Jocassee and Keowee Dams, Breach Parameter Review

Breach Parameter Review

February 2013

Jocassee Dam – Breach Parameter Independent Review

Figure 4a. Briaud (2008) erosion categories for soils and rocks based on velocity.

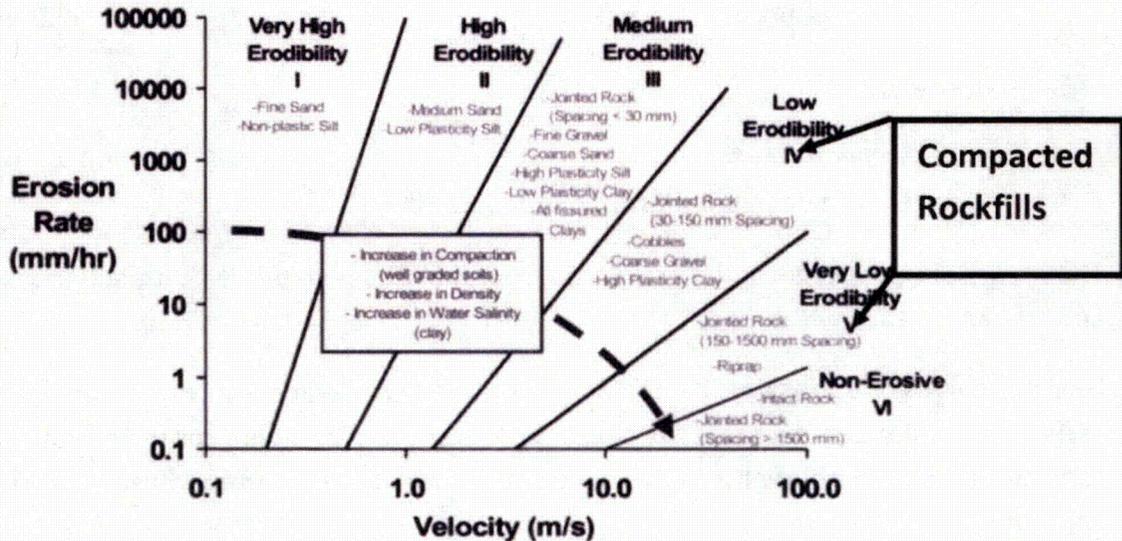
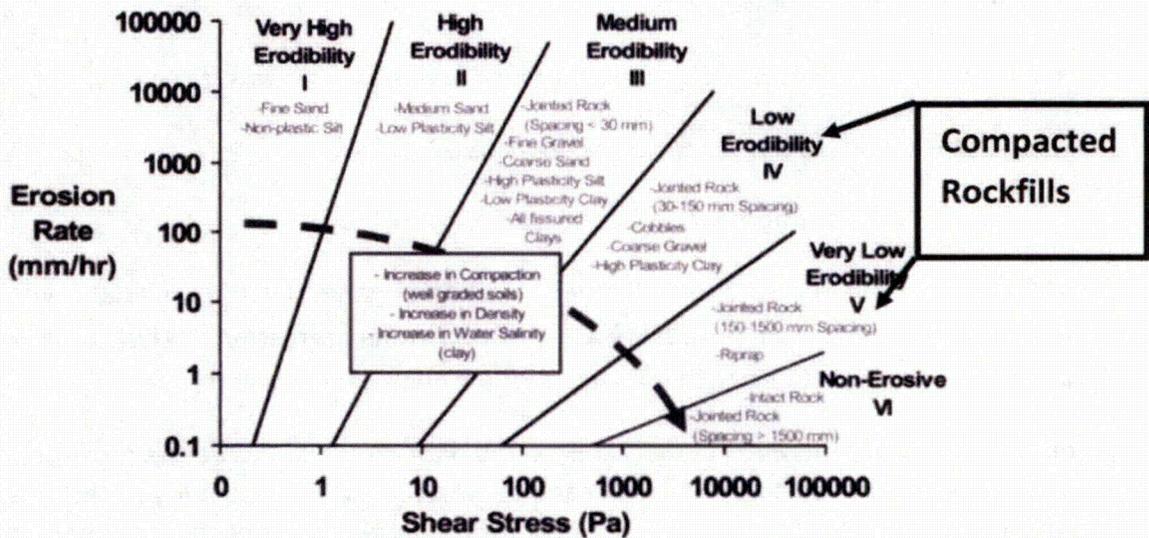
zone. These considerations would conservatively place the Jocassee Dam embankment in the low erodibility category (IV) and likely in the very low erodibility category (V).

As discussed earlier, the Xu and Zhang equations incorporated the various erosion resistance categories (low, medium or high) based on the technical paper by Briaud (2008). Our interpretation, based on the rockfill materials, compaction and density, places the rockfill at Jocassee Dam between the very low and low erodibility categories (see Figures 4a and b).

Therefore, we recommend that the most appropriate and conservative breach parameters for Jocassee Dam should be based on using the low erodibility values.

Figure 5. Relative width of confidence intervals for Xu and Zhang (2009) breach parameter estimates for Jocassee Dam based on low erodibility expressed as a ratio to the mean estimate (ratio = 1.0).

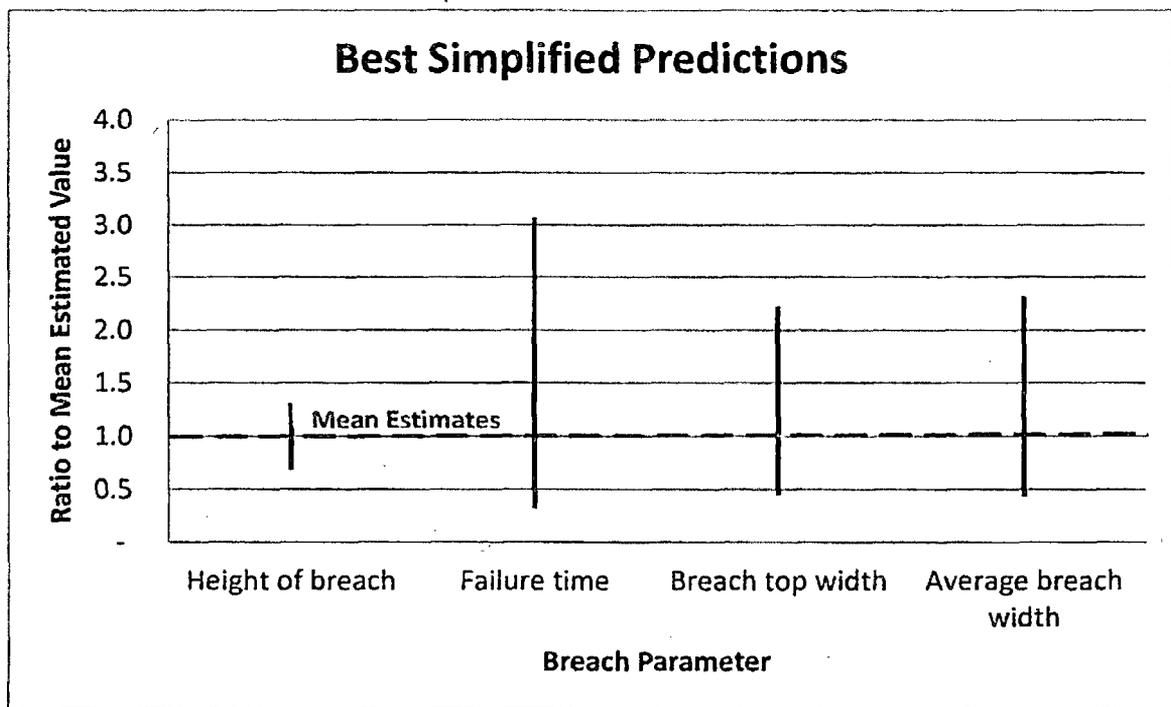
The confidence interval estimates for each breach parameter are shown in Table 2 as lower and upper bound estimates that define the width of the confidence interval both below and above the mean estimates. Similar to the examples for Banqiao and Teton dams, which we discuss in Section 6.2, the asymmetry in the confidence intervals can be seen for all breach parameters except height of the breach, which is symmetrical because of the additive form of the regression equations for height of the breach as explained in Section 6.2. The symmetry in breach parameter estimates for height of breach and the asymmetry in estimates for failure time, breach top width, and average breach width can be seen in Figures 5a and b. In these figures the confidence intervals for breach parameter estimates for Jocassee Dam are plotted as a ratio to the mean estimate for the Xu and Zhang (2009) Best Exact and Best Simplified Prediction equations, respectively. The asymmetry in the confidence intervals for failure time, breach top width, and average breach width can be seen by the longer lines above the mean estimate (plotted at a ratio = 1.0 shown by the blue dashed line) than below the mean estimate.

In Table 2 we have placed boxes around the values of the breach parameters that we recommend as being most applicable to Jocassee Dam. These are mean estimates based on low erodibility. The basis for using low erodibility is explained earlier in this section and is based on discussions in Sections 3.0 and 6.1. The basis for using mean estimates is discussed here.

Figure 6. HDR's HEC-RAS Jocassee Dam breach hydrographs

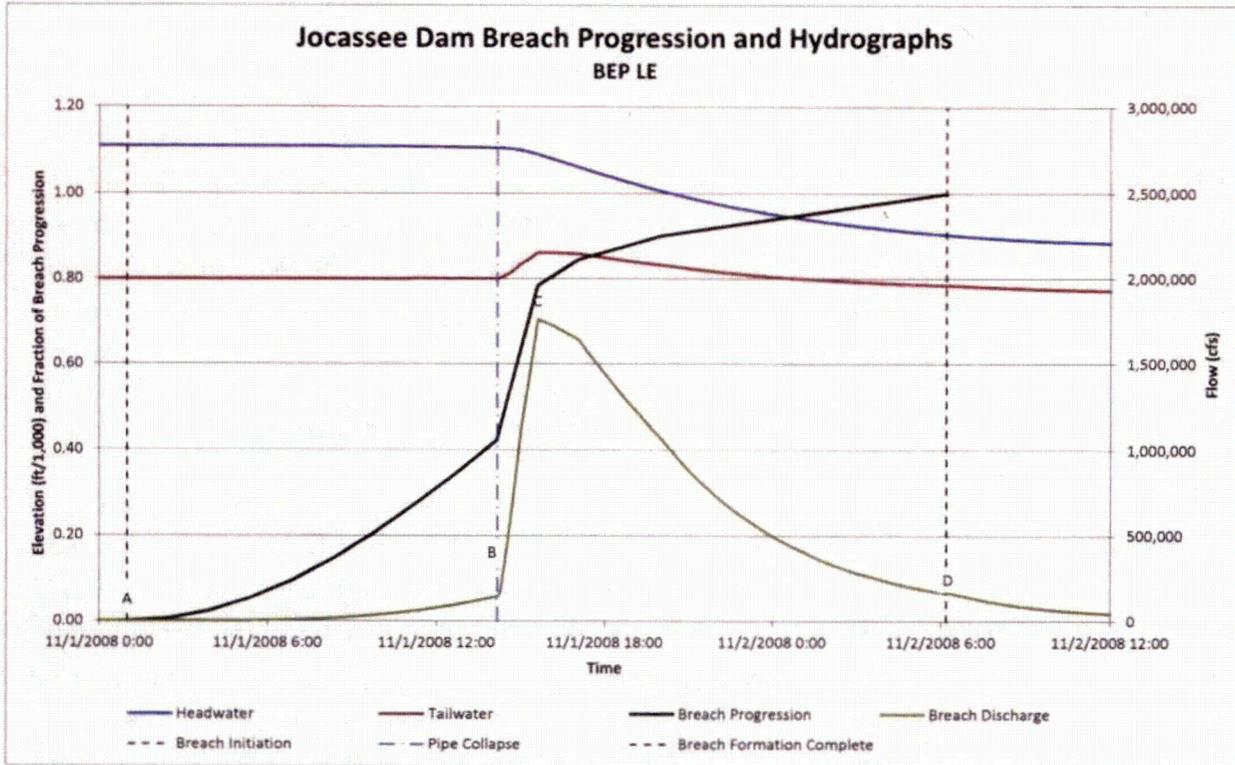
The importance of consistency between the definition of the Xu and Zhang (2009) failure time when using failure time estimates in the HEC-RAS breach model is pointed out in Section 5.0. Figure 6 contains breach hydrographs for headwater (blue line related to left scale * 1,000), tailwater (brown line related the left scale * 1,000) and breach discharge (green line related to the right scale) obtained by HDR for a piping failure of Jocassee Dam at a location immediately downstream of the internal boundary in HEC-RAS model that represents the dam. The rate of breach progression that is defined as a HEC-RAS input is shown by the black line (related to the left scale). Points A, B and D are equivalent to points that are defined in Figure 3 for the Teton Dam failure in Section 5.0.

To achieve a compatible implementation of the Xu and Zhang breach parameter estimates in HEC-RAS the Xu and Zhang mean breach failure time (between points A and D) and mean breach geometry estimates were input to the HEC-RAS model. The Xu and Zhang mean peak breach flow rate estimate was then closely matched by adjusting the piping coefficient to a value of 0.1, the breach weir coefficient to a value of 2.0, and the sinusoidal rate of breach progression relationship was adjusted between points B and D as shown in Figure 6.

The adjusted values of these coefficients appear to be reasonable in terms of representing flow through the rockfill material and flow through the breach following collapse of the dam crest of the rockfill dam, respectively. In addition the form of the resulting breach hydrograph also appears to be reasonable for a piping failure mode and closely matches the Xu and Zhang mean peak breach flow rate estimate. We consider this to be a *realistic but conservative* breach hydrograph that has good *defendability* based on the validity of the Xu and Zhang (2009) method, the conservative nature of the mean breach parameter estimates, a piping failure mode initiating in the abutment, the deposition of rockfill immediately below the dam, the low erodibility of the rockfill material, and various characteristics of a modern dam that were include in the design and construction of Jocassee Dam.
